**Project Reference: FDC3564**

**Re: The Cutaway – Construction Noise and Vibration Management Plan (CNVMP) – Monitoring Program Update**

Reference is made to the Contractor obligations regarding noise and vibration monitoring for the duration of the project as described in the CNVMP (doc. Ref. 20240418 FDC3564 Rep.0001-CNVMP\_v1.0) and the relevant conditions in the Development Consent for the Proposal (Application Number SSD 47498458). Changes to the monitoring program as proposed by FDC are:

**Figure 1** Long-term unattended monitoring locations around the Project site – Noise (RED) and Vibration (BLUE)

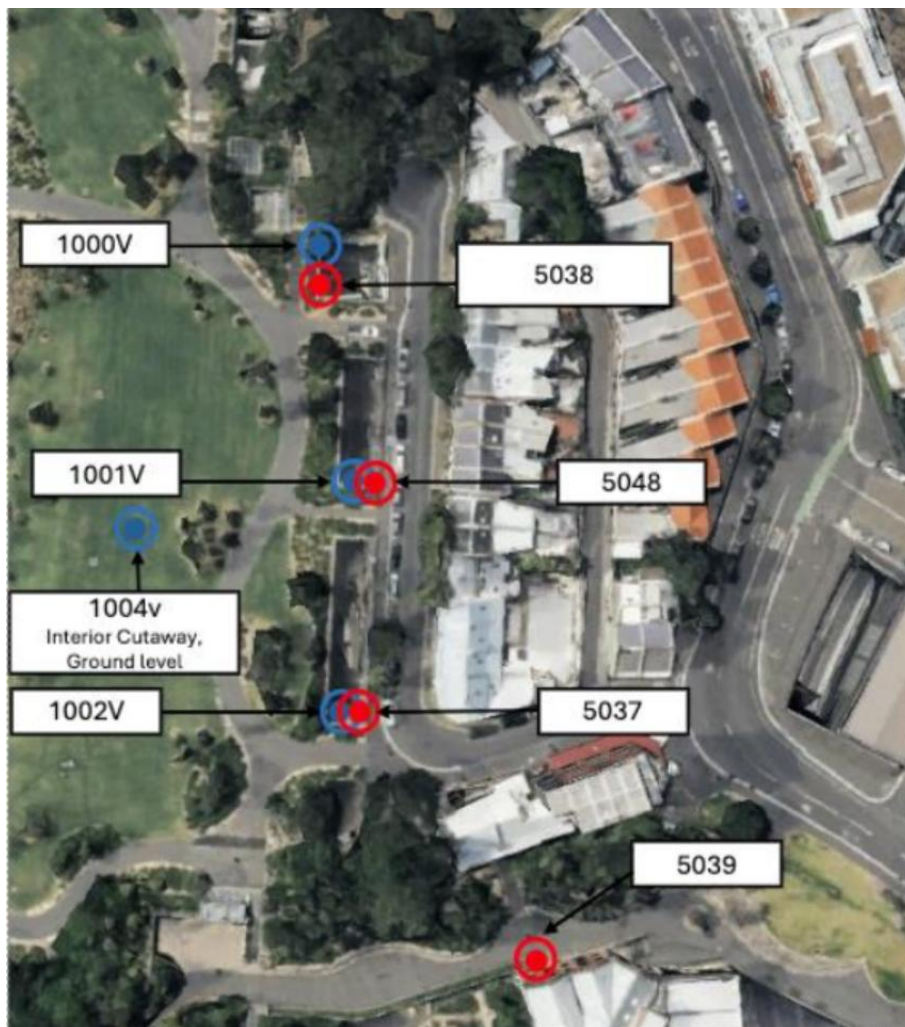
- The monitoring program during the reporting period has been implemented in general accordance with the Project CNVMP<sup>1</sup>, particularly Section 7 of the CNVMP “Monitoring Program” as per the observations below extracted from NN’s monitoring reports:
  - Monitor time traces show that site generally keeps to approved hours (i.e. no works before 7am or 8am Saturdays).
  - The respite periods are observed when high-noise works occur (i.e. no more than 3 hours of high-impact works).
  - For OOH works (before 7am) FDC confirms that it provided written notice to all affected receivers.
  - NN states in the reports that all exceedances have been analysed, including listening to noise recordings to exclude activities that are not FDC site-related, and feedback requested from FDC for any noise vibration exceedances.

- Noise and vibration exceedances shown in the monitoring reports that were deemed to be caused by Project site works were investigated by FDC, corrective measures were implemented where possible and that no outstanding complaints are currently open with nearby sensitive receivers to the site (e.g. terraces in Merriman St).
- Monitoring reports referred to in this section correspond to the site works and activities as listed in Section 2.1 (i.e. Completed works) below and that these works were either undertaken at surface level or within the Cutaway underground spaces but before the skylights to the west of Merriman Street were enclosed (i.e. before May 2025).

**Figure 2** Proposed long-term unattended monitoring suitable locations for the remaining of the works – Noise (RED) and Vibration (BLUE)

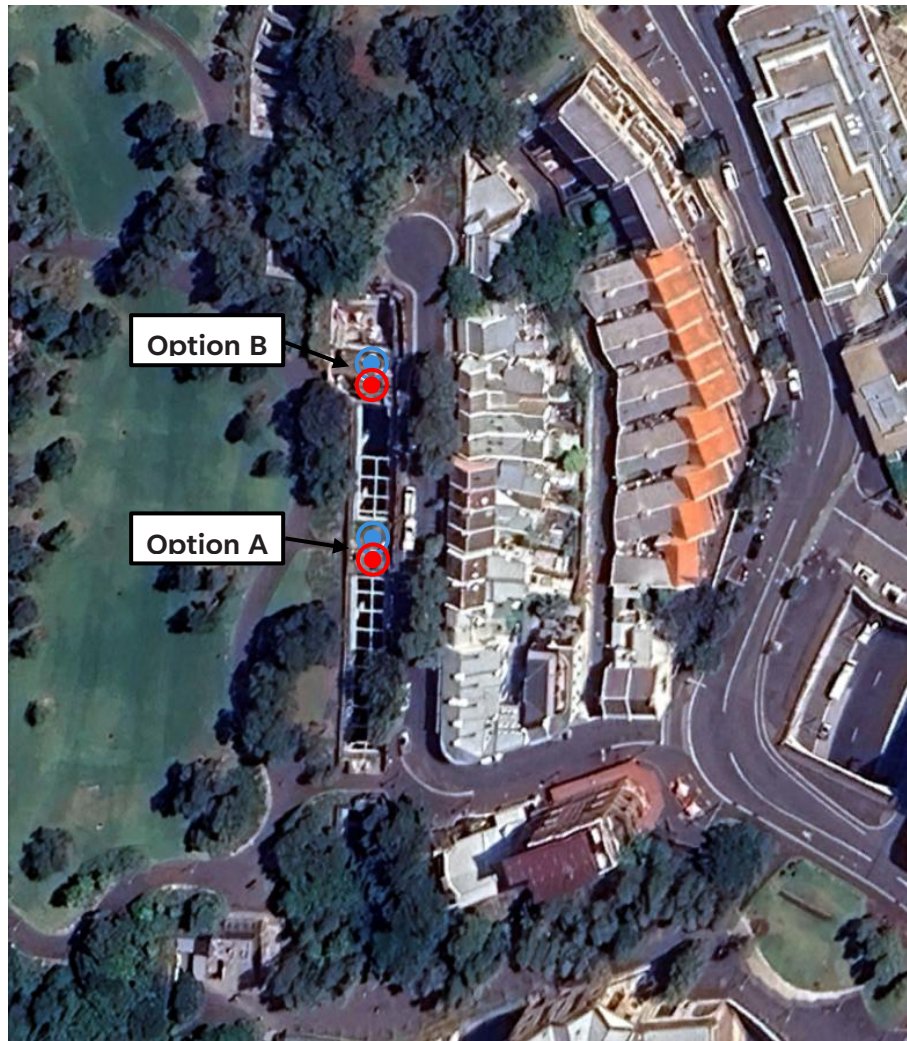
- Remove 3 of the 4 long-term unattended noise monitors labelled in Figure 1 as 5038, 5037 and 5039.
- Remove 3 of the 4 long-term unattended vibration monitors labelled in Figure 1 as 1000V, 1002V and 1004V.
- Relocate the remaining noise (5058) and vibration (1001V) long-term unattended monitors – or equivalent available monitors – to a suitable location at the top of the enclosed skylights which is still in the vicinity of the nearest residential receivers in Merriman Street, Millers Point, but not interfering with the remaining works in the program. Refer to Figure 2 for the proposed new locations of monitors to remain on site.

- The number and location of monitors proposed by FDC to stay on site is adequate to the nature of the remaining works from May 2025 and upon completion so long as the Contractor keeps on applying all of the recommendations on the CNVMP (where applicable) for the remaining works such as, but not limited to:

- Monitor the time traces provided by the remaining unattended monitors to ensure that site activities remain within the approved working hours set out in the Conditions of Consent.

- Observe respite periods when high-noise external works are planned in the vicinity of sensitive receivers such as for any landscaping works along Merriman Street (i.e. no more than 3 hours of high-impact works).

- FDC to provide 48-hours-prior written notice to all affected receivers for any planned OOH works (before 7am).
  - If exceedances are recorded by the monitors, those are to be analysed and, if found to be caused by FDC works, action should be taken by FDC in accordance with the CNVMP<sup>1</sup>.

- Generally, continue to apply all feasible and reasonable noise and vibration control measures in the CNVMP<sup>1</sup> for the remaining works, including but not limited to communication with affected sensitive receivers and prompt follow up of any complaints that may arise in the future. This is despite our view that complaints are unlikely due to the low noise and vibration risks associated with the remaining works.
